RE: 10_0147, Life City Wollongong - Hi-Tech Holistic Cancer & Medical Hospital Campus Warwick Street, Nolan Street Berkeley

Objections based on the Traffic and Transport Assessment.

The more accurate figures for 'Peak Hour Traffic Generation Potential' would be:

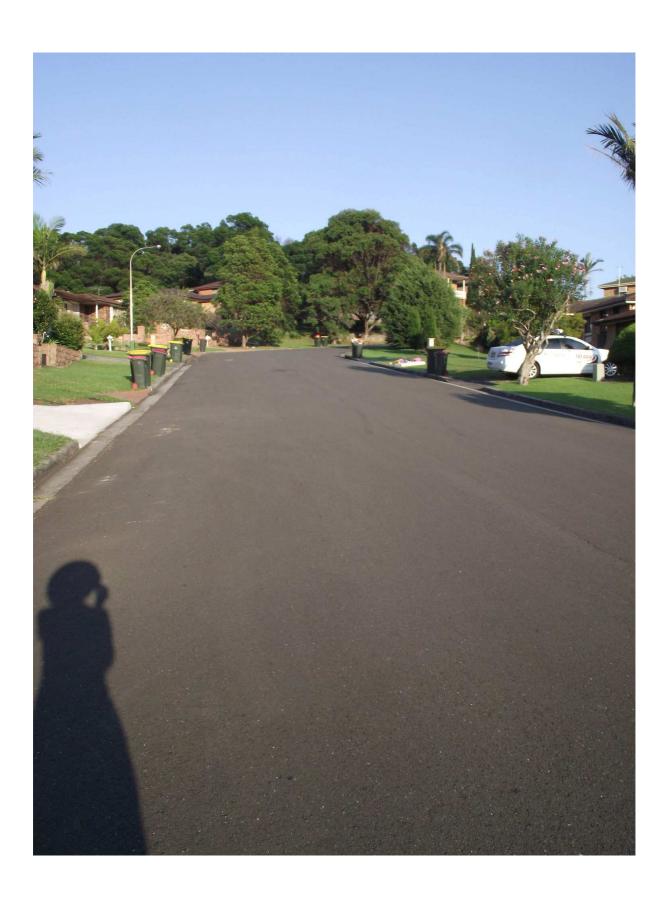
Given the lack of public transport, as indicated above, and the expected high percentage of employees that would drive to the site, then section "3.2 Projected Traffic Generation" of the Assessment is just wrong as it's based on faulty assumptions and erroneous traffic volumes.

Morning Peak (vtph) IN 1,369 Morning Peak (vtph) OUT 1,369 Evening Peak (vtph) IN 1,369 Evening Peak (vtph) IN 1,369

In other words, over 1,000 more traffic movements that that stated.
